STATE OF MAINE
DEPARTMENT OF TRANSPORTATION
16 STATE HOUSE STATION
AUGUSTA, MAINE
04333-0016

May 5, 2008
Subject: **Norridgewock**
Project No. BH-6900(01) X
Pin No.006900.01
Amendment No. 2

Make the following changes to the Bid Documents:

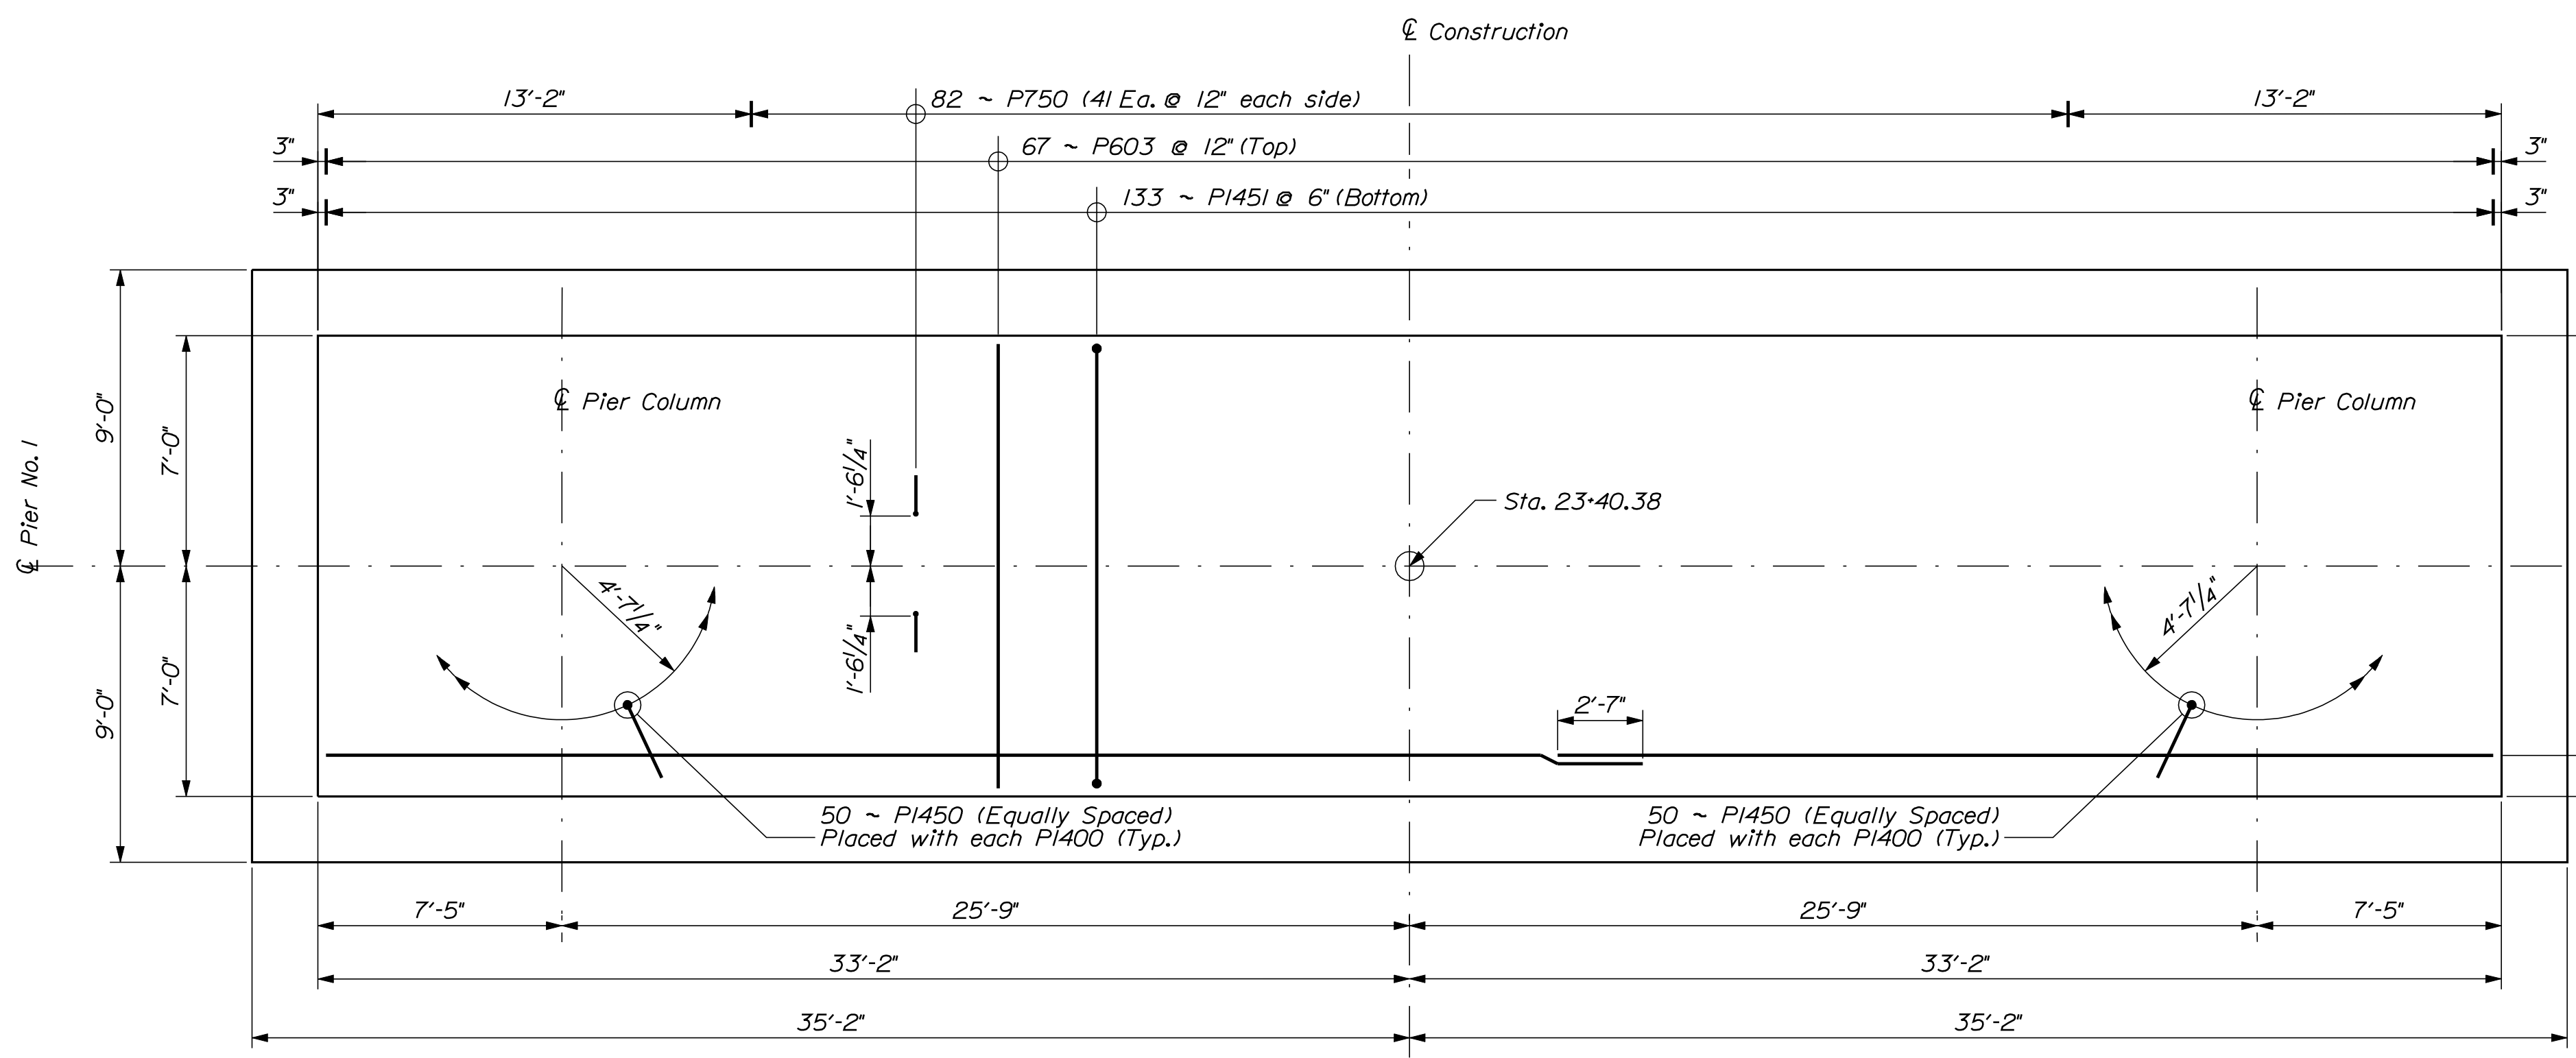
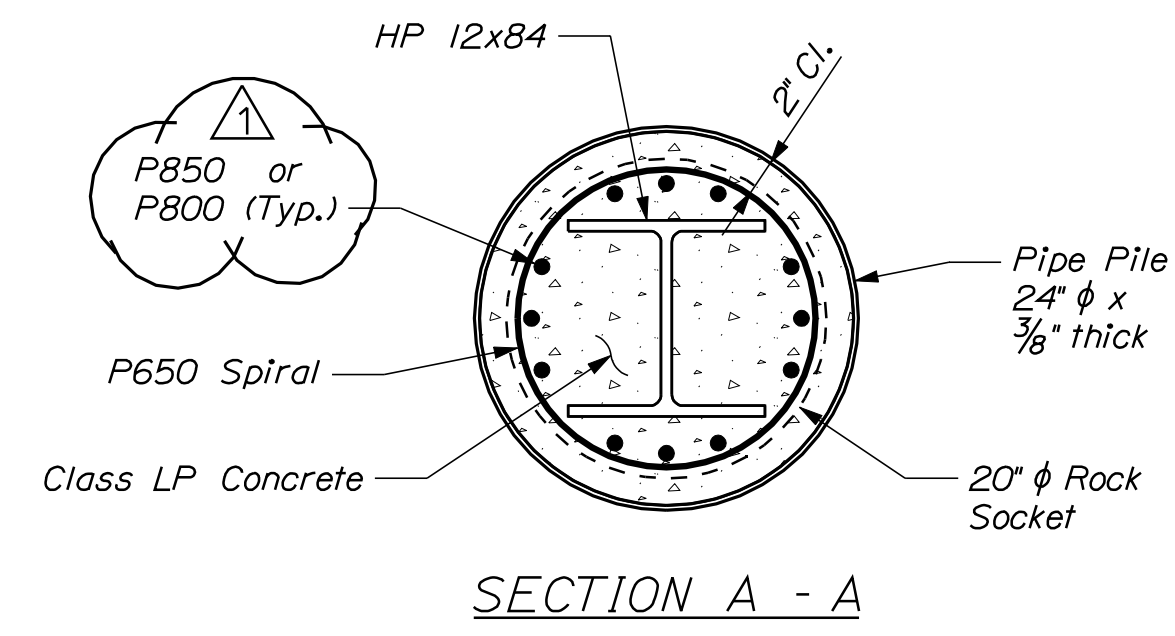
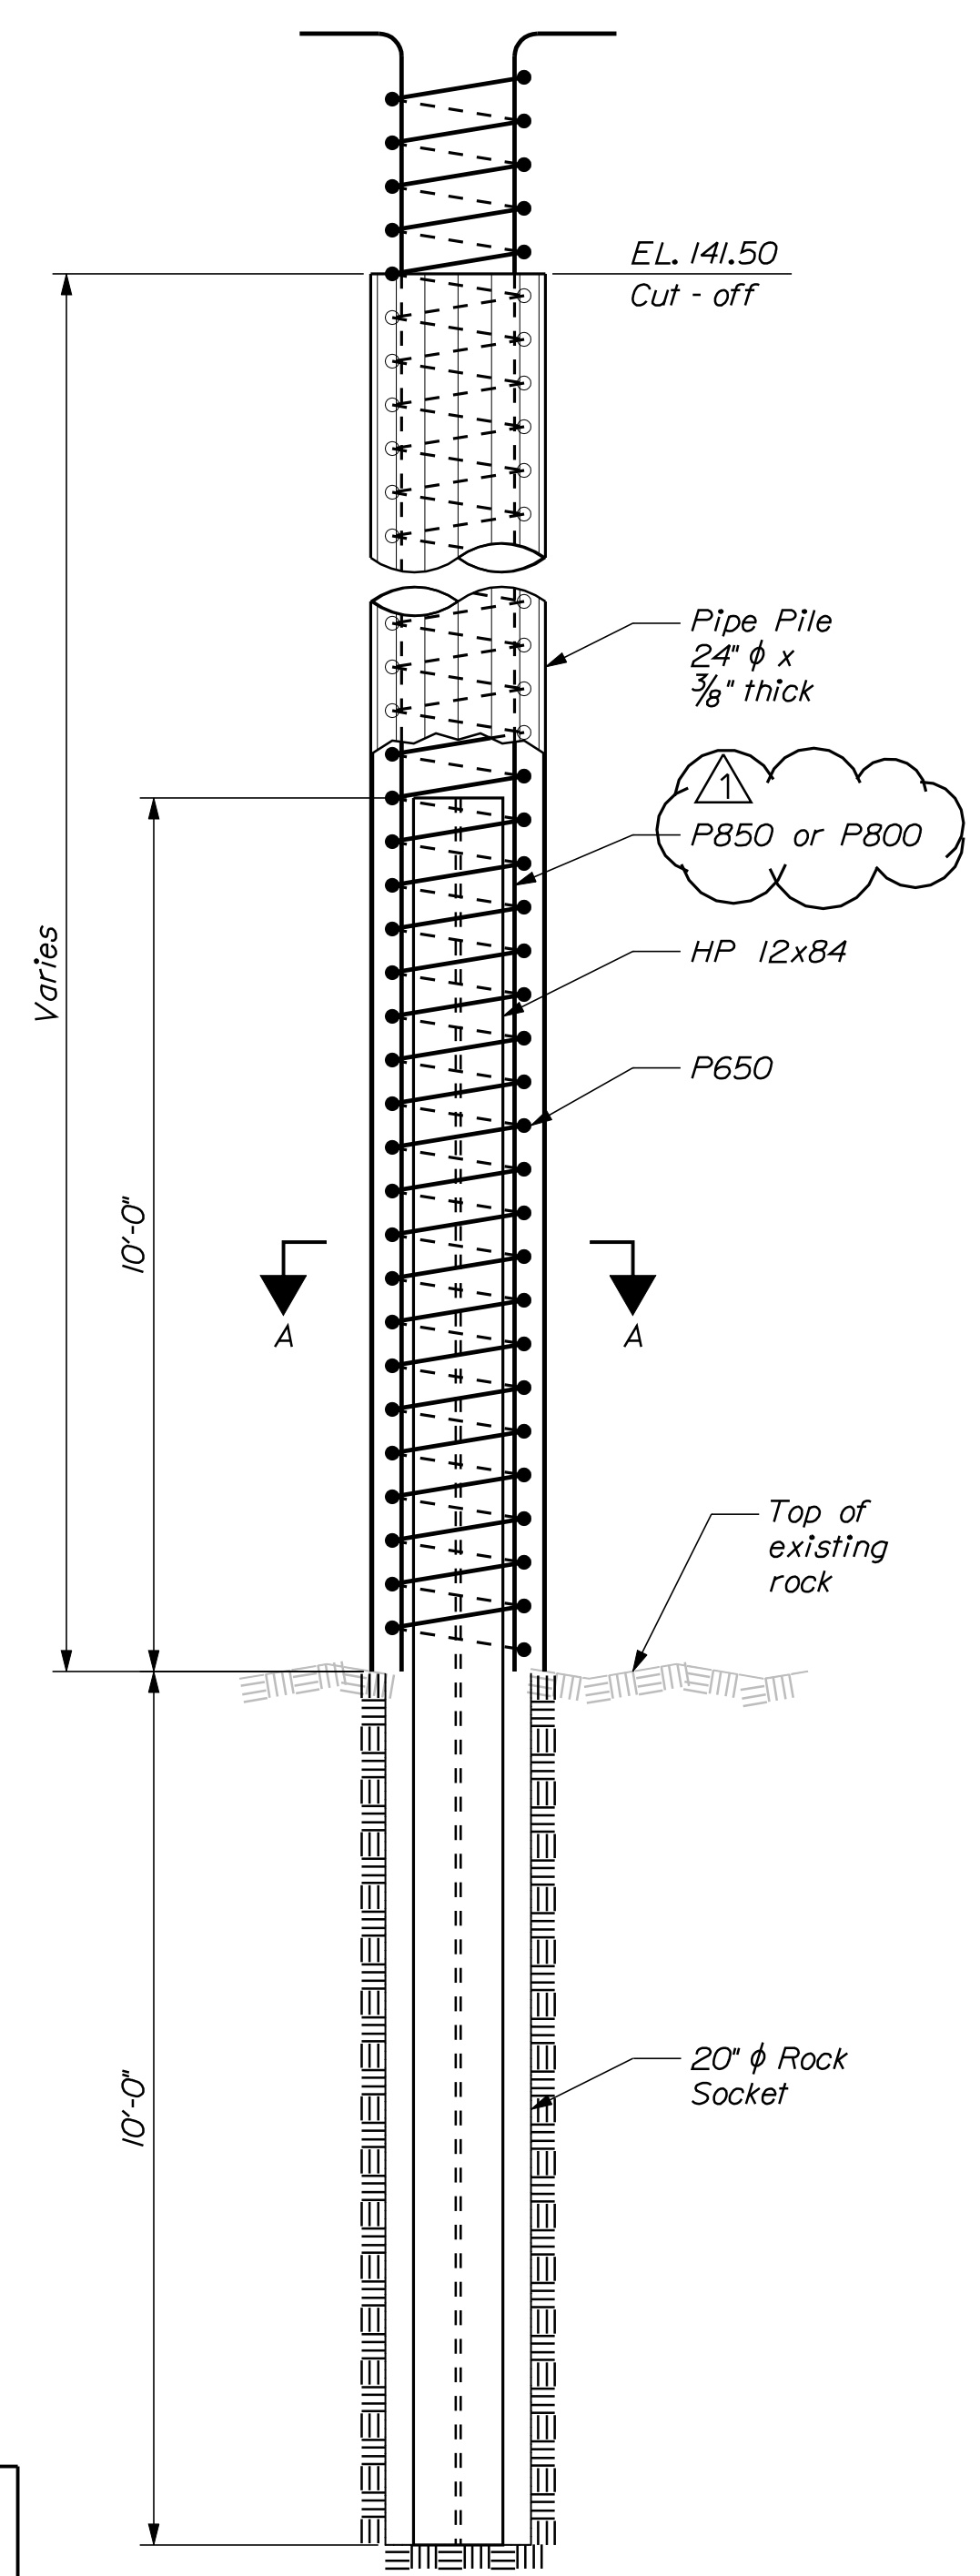
From the plans, **REMOVE** Sheet 67 of 134 and **REPLACE** with the attached new Sheet 67 of 134.
